Re: Project PR-2018-001280 – Proposed Minor Amendment

The purpose of this letter is to explain our request for a minor amendment to the approved Site Development Plan for the Markana Apartments (Phase 2) located at 6201 Alameda Blvd NE. The purpose of the amendment is to adjust the parking calculations to correct an error in the table from the original approval. The subject property is legally described as Lot 1-A, Block 28, North Albuquerque Acres, Tract A, Unit B and zoned R-MH.

MARKANA APARTMENTS - II

A1.10

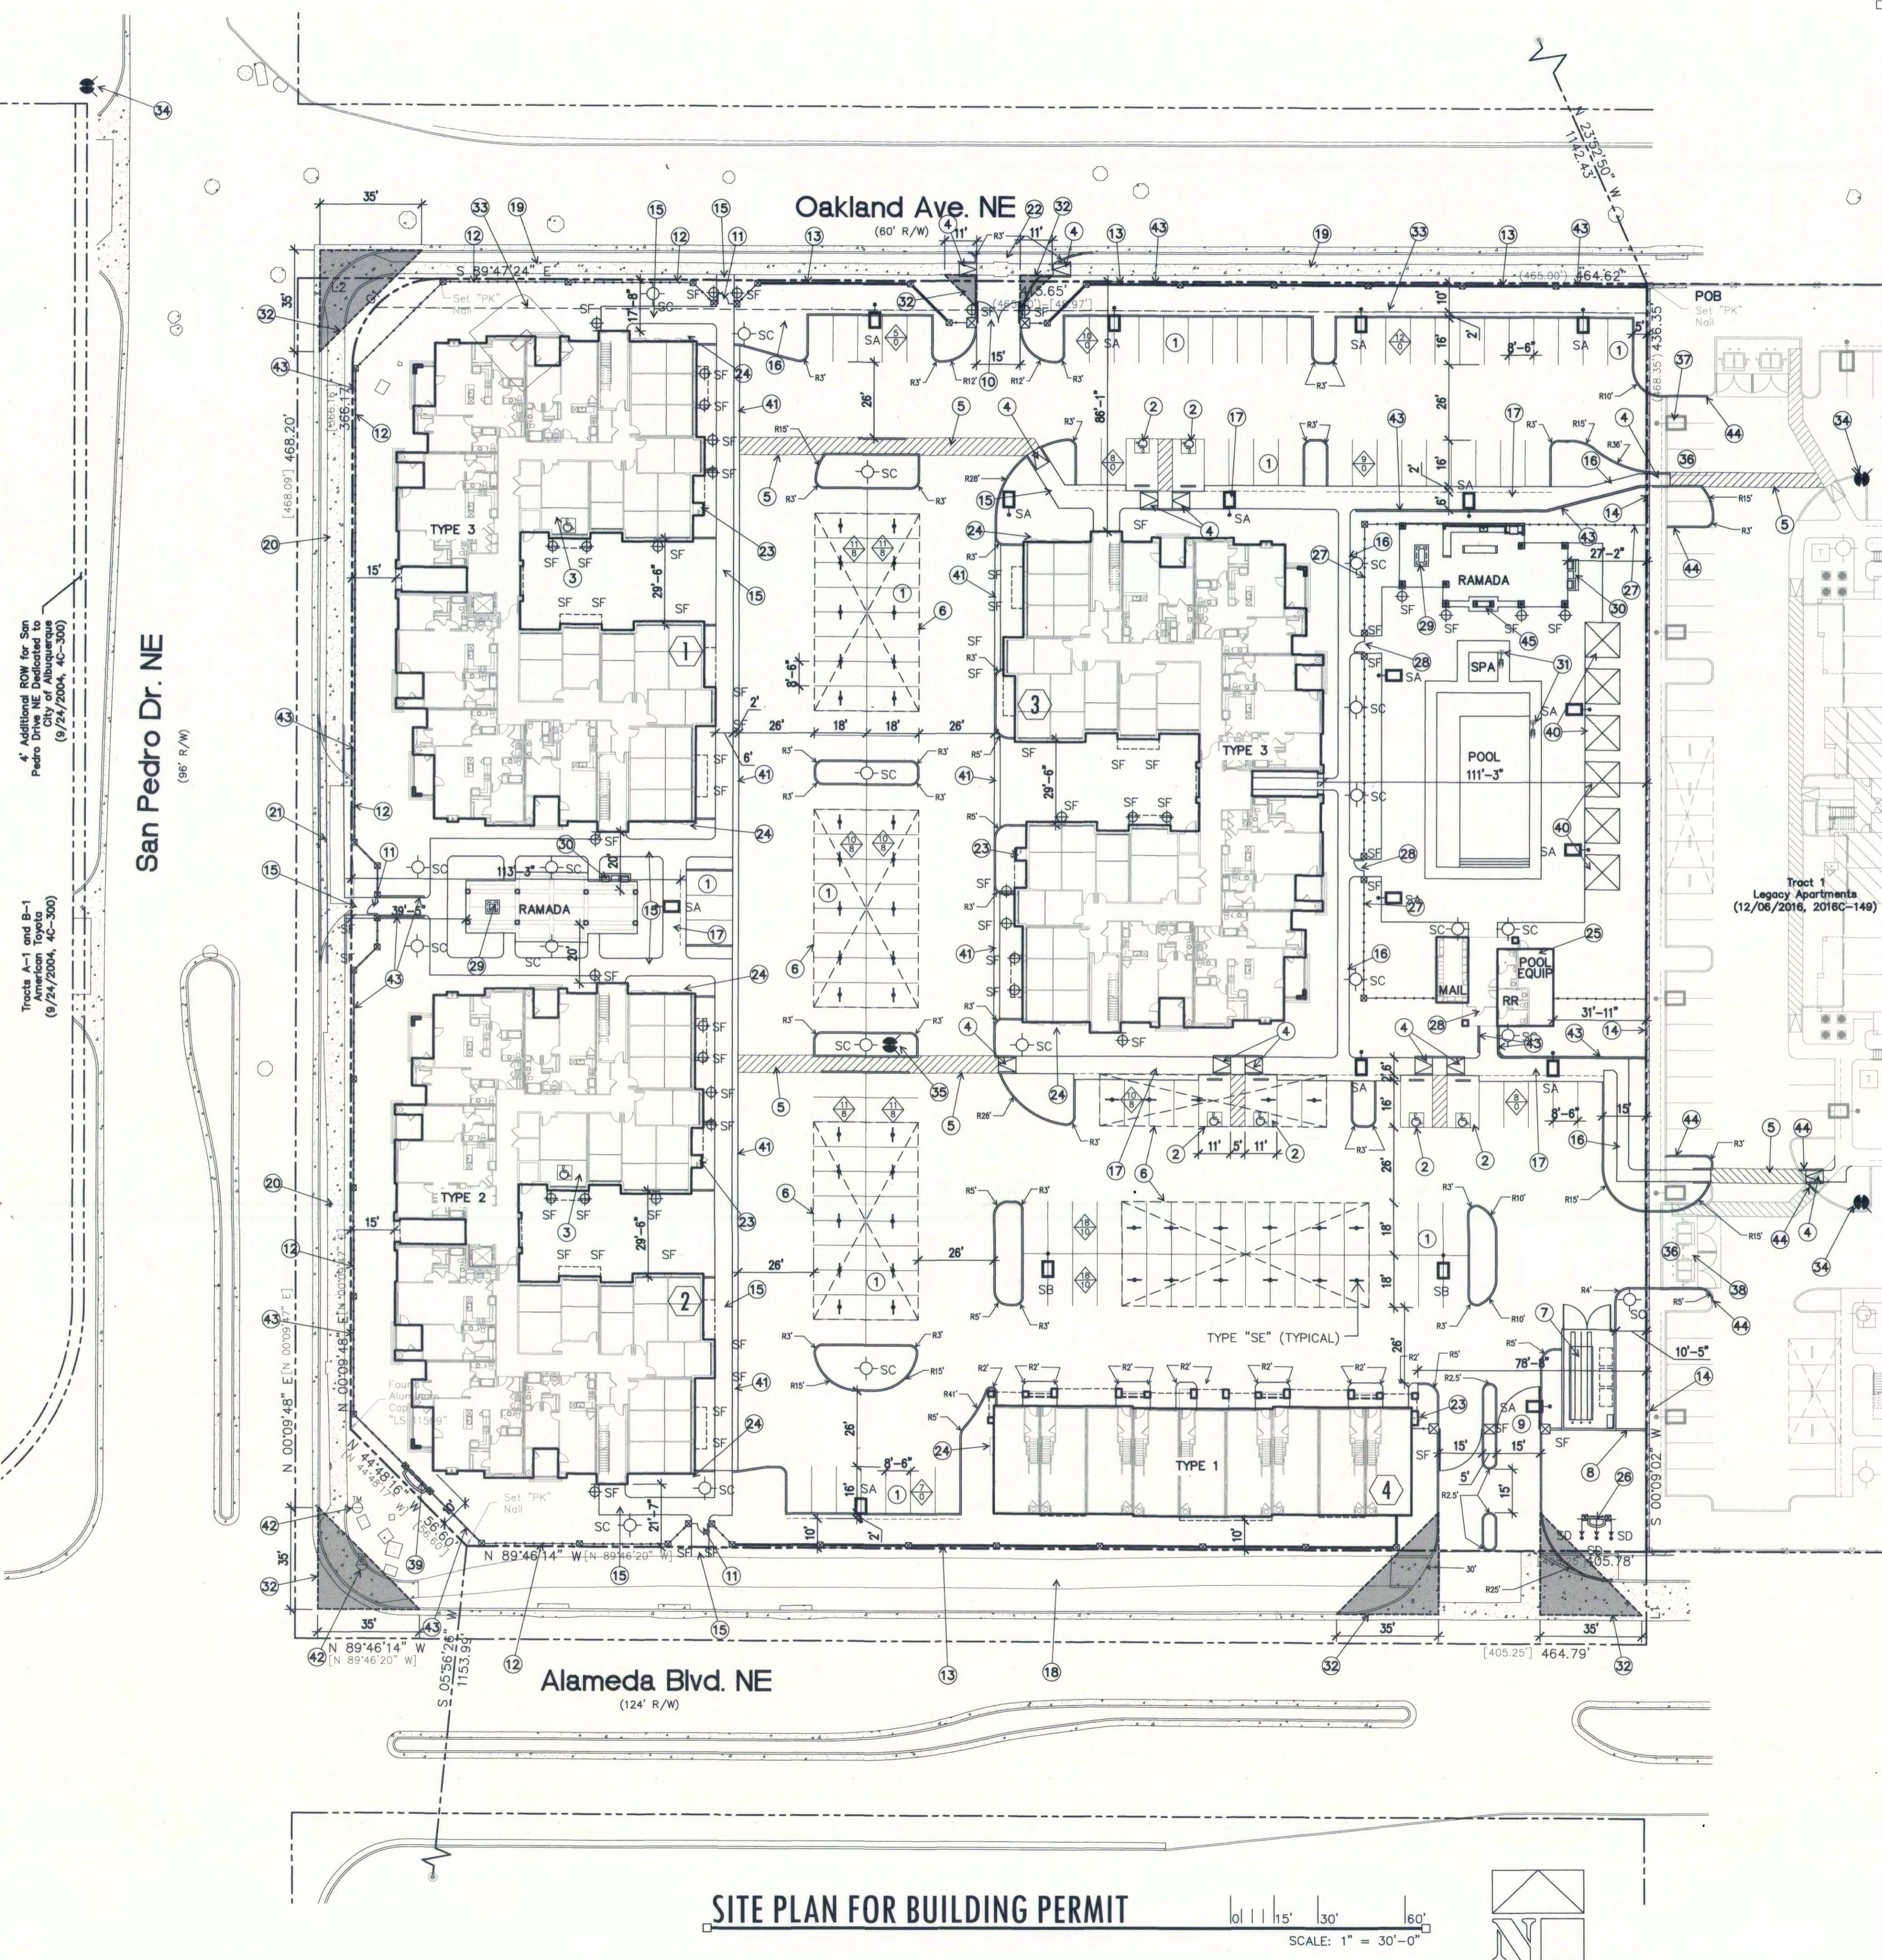
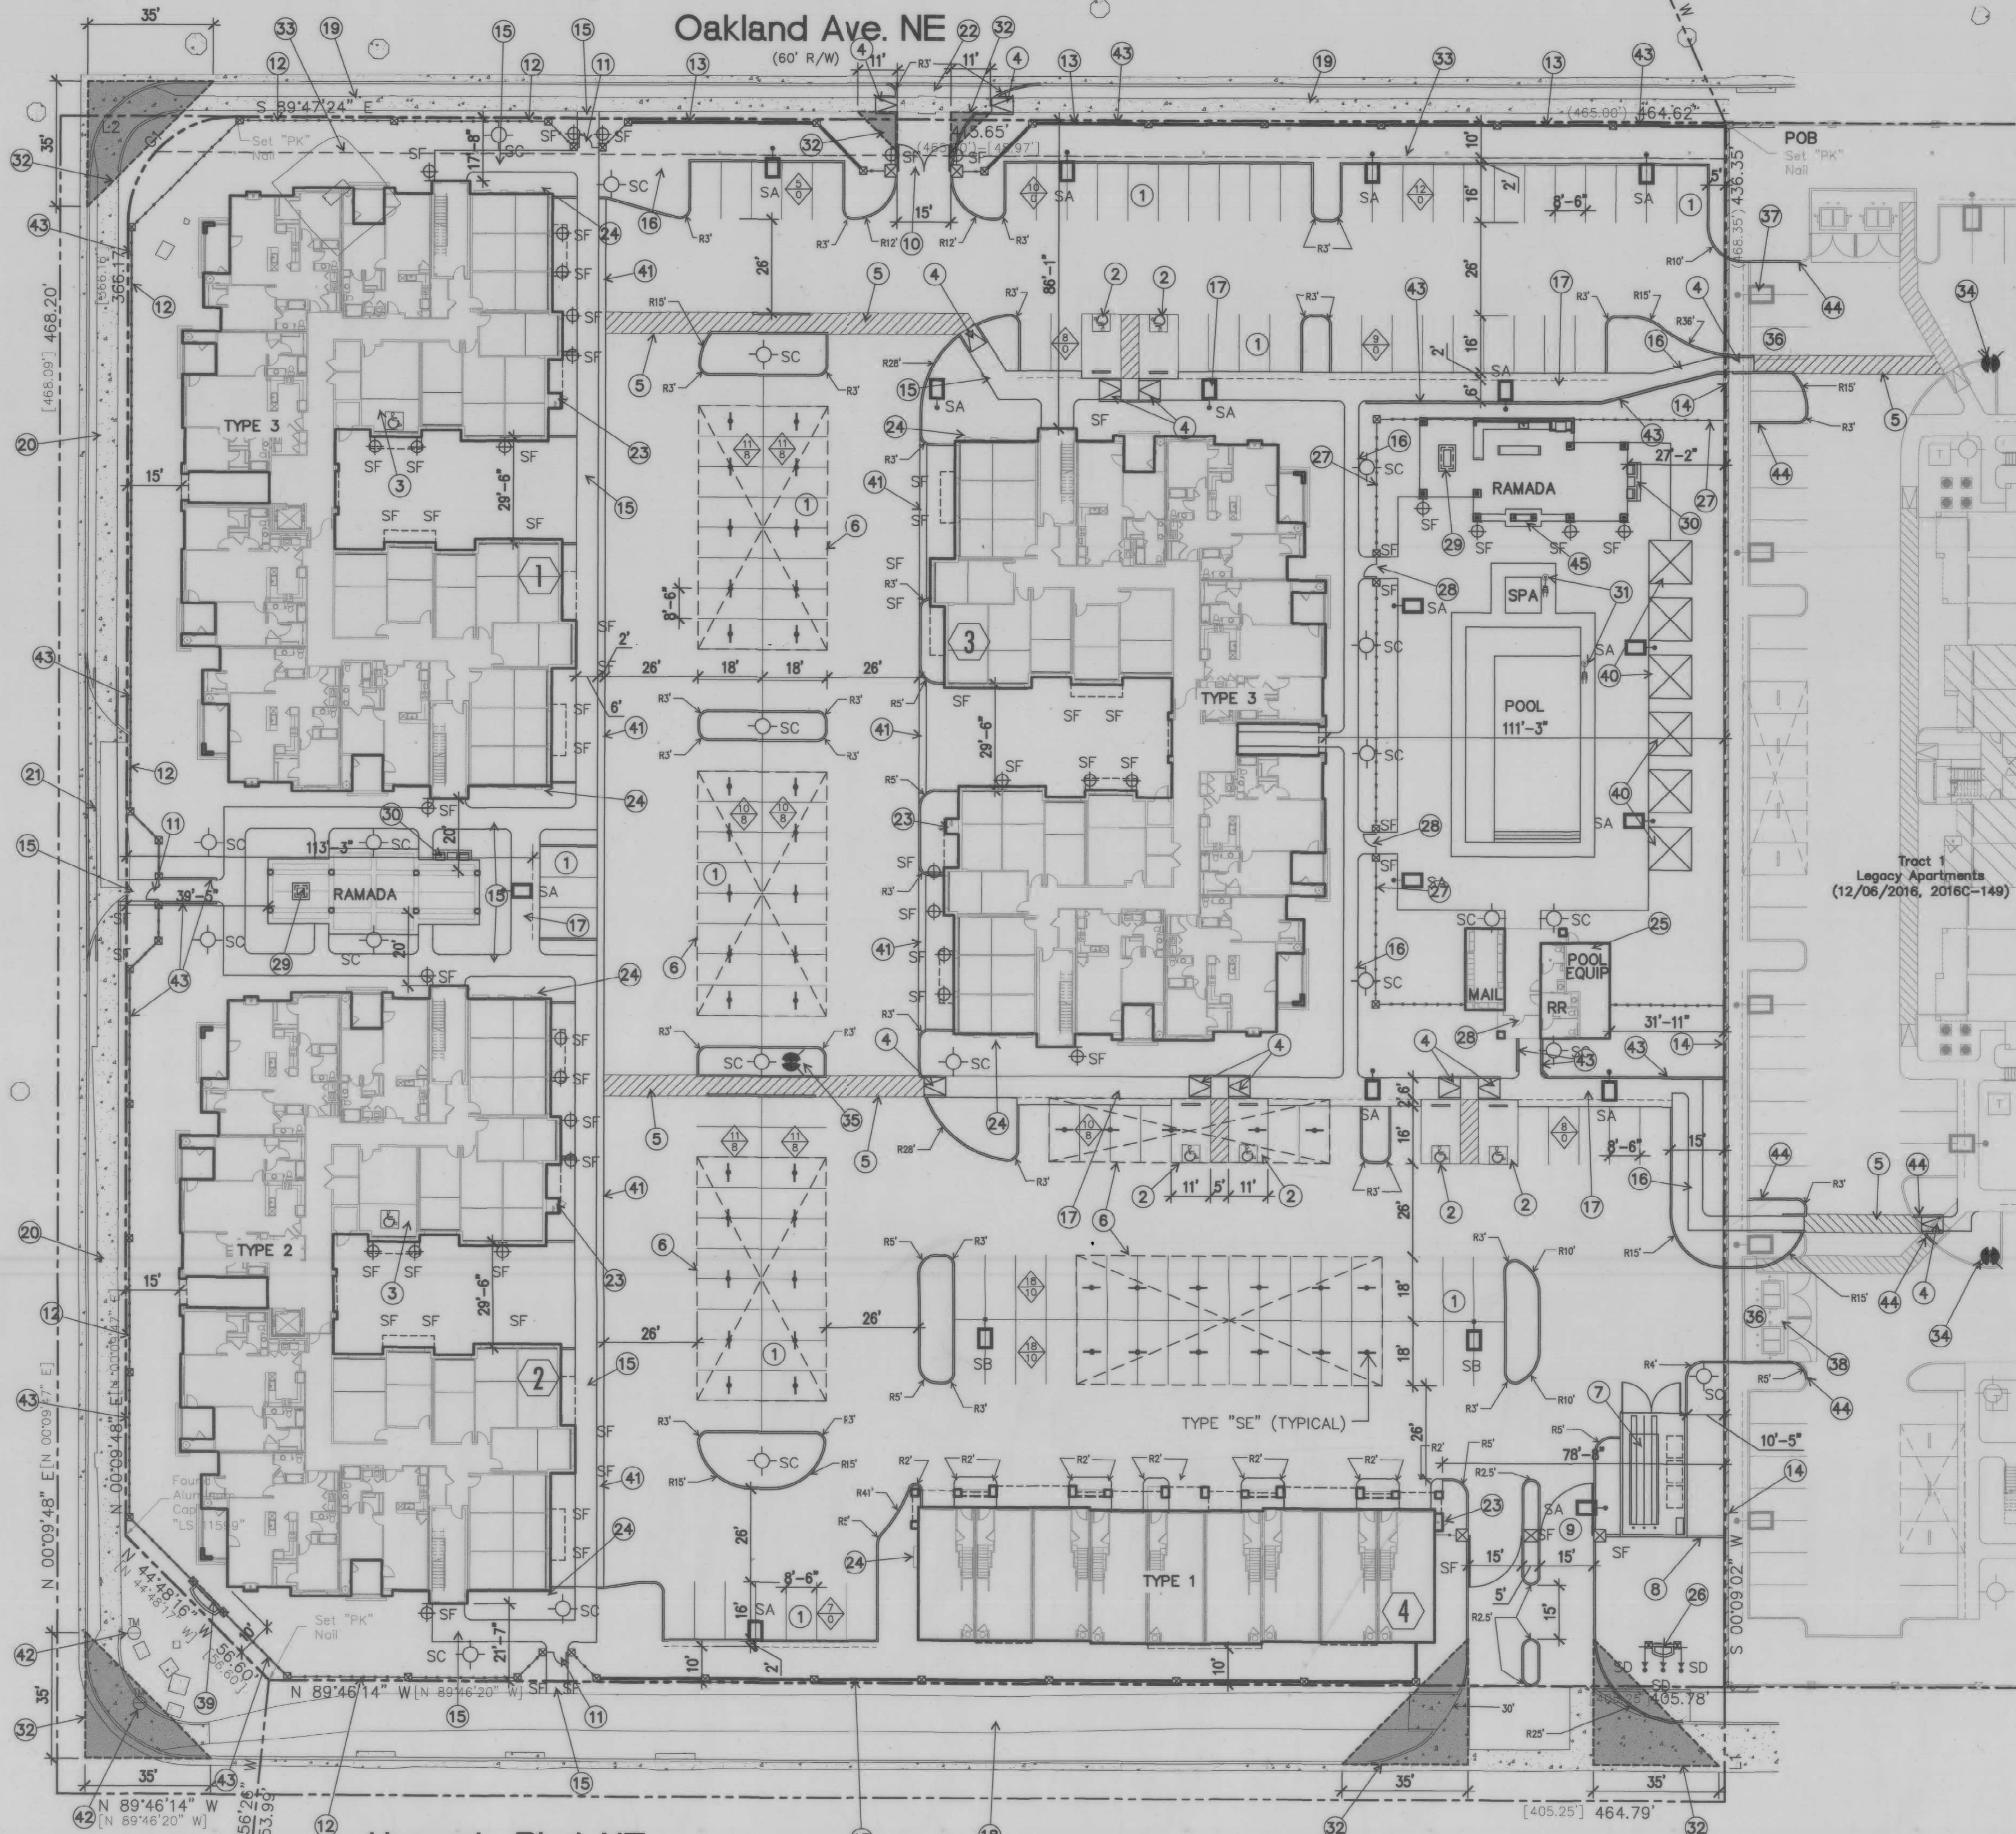
The requested minor amendment is to update the parking calculations to correct an error that was made in the original approvals:

- Addition of three parking spaces that were shown, but not counted in the parking calculations on the prior approvals.

Applicant Response: *The approved Site Development Plan underwent a Major Amendment and shows the parking required utilizing the IDO standards of 1.5 spaces per dwelling unit. The development meets this standard and the amendment only increases the number of spaces provided in excess of the minimum requirement from 35 to 38 that can be utilized by Phase 1 of the Markana Apartments. The current plan dedicated six spaces to Phase 1 that were lost in order to provide vehicular access between the two phases. Concurrent to this minor amendment, the Applicant is requesting a minor amendment to Phase 1 that reduces the parking on the adjacent property by 9 additional spaces. Even adjusting for those 9 spaces, there are 23 spaces left in excess of the parking requirements for both phases of development.*

Applicant Response: *The requested change in the number of parking spaces are simply a correction for a miscalculation in the original approvals and do not change the number of actual spaces provided onsite. With no change to the total amount of parking, the request is within the thresholds allowed for administrative amendments.*

As Built - Parking Count Revised August / 19/ 2020
